TSB#: 12-010S

2013 Autumn Ridge Travel Trailers

Technical Service Bulletin Notification TSB#12-010S

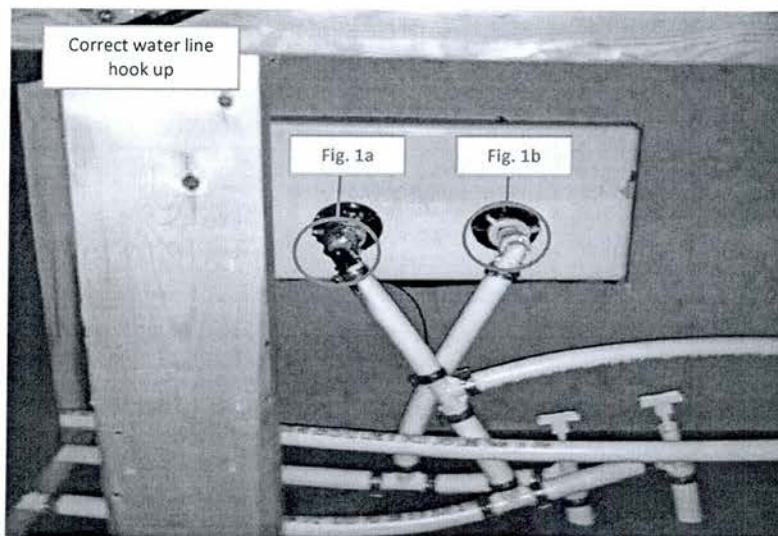
1. First determine if the water lines are incorrectly hooked up. To do so, go into the unit and lift the bed top on the rear bed. As you look at the connections, the water line with the black paint on the elbow should be on the left (Fig. 1a) and the white elbow should be on the right (Fig. 1b). If the water lines are hooked up this way, no further action is required. If they are not hooked up this way, loosen and remove the water lines and replace them with the black on the left and the white on the right.

Inspect the outside shower to determine if the hot and cold lines are reversed. If they are reversed, disconnect and hook them back up to the correctly.
